AUI-C2C transmitter equalization control interface proposal

(Addressing comments 11059, 11082)

Adee Ran, Intel

Figure 120F-2—Typical 100GAUI-1, 200GAUI-2, and 400GAUI-4 C2C application

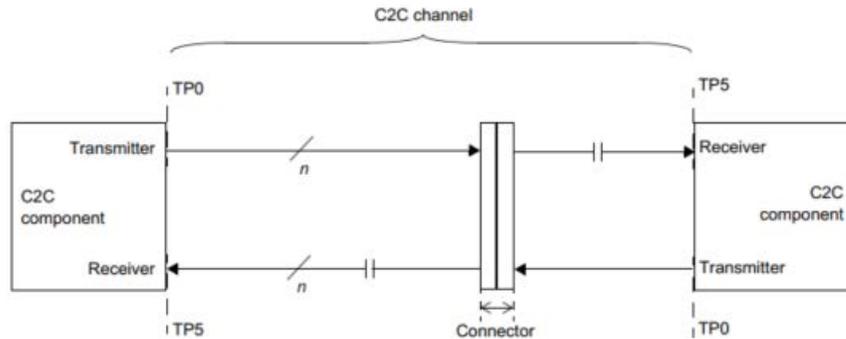
Chip-to-chip transmitter equalization register definitions have been written as being general for 100/200/400GAUI-n but 100GAUI-1, 200GAUI-2, and 400GAUI-4 appear to be on a trajectory to have different tap counts and coefficient step sizes.

The 100GAUI-1, 200GAUI-2, and 400GAUI-4 C2C transmitter on each end of the link is adjusted to an appropriate setting based on channel knowledge. If implemented, the transmitter equalization feedback mechanism described in 120D.3.2.3 may be used to identify an appropriate setting. The adaptive or adjustable receiver performs the remainder of the equalization.

Annex 120F text refers to a control interface of 120D - 3-tap TxEq using absolute tap values

The correct amendment to 45.2.1.129 through 45.2.1.132 seems to be to indicate these registers are specific to 100GAUI-n (n > 1), 200GAUI-n (n > 2) and 400GAUI-n (n > 4) until the Annex 120F taps counts, coefficient step sizes, and control scheme are finalized. At this point it seems likely a different set of registers would be needed for Annex 120F controls.

Figure 120F-4—Transmitter equalizer functional model

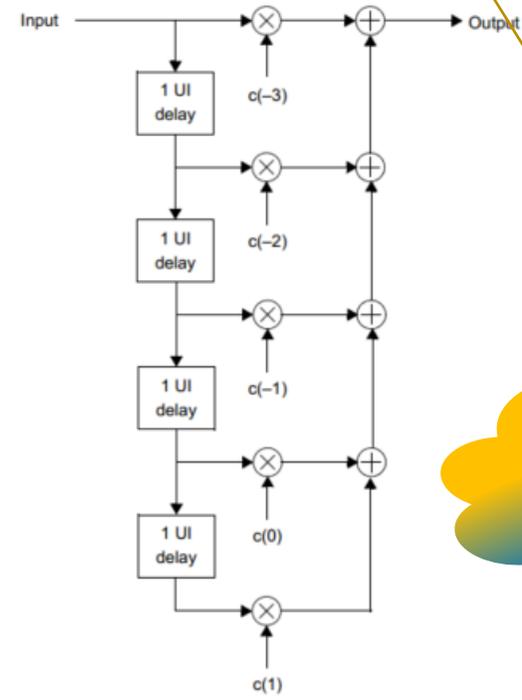
The TxEq is specified with 5 taps

Mess...
A new control interface is required

- Define a register-based control interface as in 120D (and 83D)
 - But based on variables in the PMD control function of 162 instead – “local” set
- Define an optional equalization feedback interface (as in the annexes above)
 - But based on variables in the PMD control function of 162 instead – “remote” set
- Make the minimal required changes to enable these interfaces in D1.3
 - As shown in the next slides
- Additional features to be discussed in future comment cycles:
 - Refinement of interface variables and registers
 - Explicit coefficient values (in addition to relative steps)
 - Using per-lane signal detect and transmitter disable in conjunction
 - Optional use of training protocol

Note—The number of lanes n is equal to 1 for 100GAUI-1, 2 for 200GAUI-2, and 4 for 400GAUI-4.
Figure 120F-2—Typical 100GAUI-1, 200GAUI-2, and 400GAUI-4 C2C application

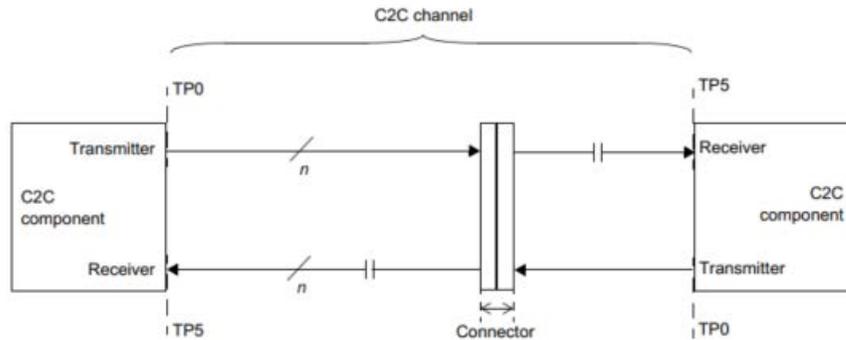
The 100GAUI-1, 200GAUI-2, and 400GAUI-4 C2C transmitter on each end of the link is adjusted to an appropriate setting based on channel knowledge. If implemented, the transmitter equalization feedback mechanism described in 120D.3.2.3 may be used to identify an appropriate setting. The adaptive or adjustable receiver performs the remainder of the equalization.

The 100GAUI-1, 200GAUI-2, and 400GAUI-4 C2C transmitter on each end of the link is adjusted to an appropriate equalization setting, which may be based on channel knowledge. If implemented, The transmitter equalization feedback mechanism described in 120F.3.3 may be used to identify an appropriate setting of the link partner. The adaptive receiver performs the remainder of the equalization.
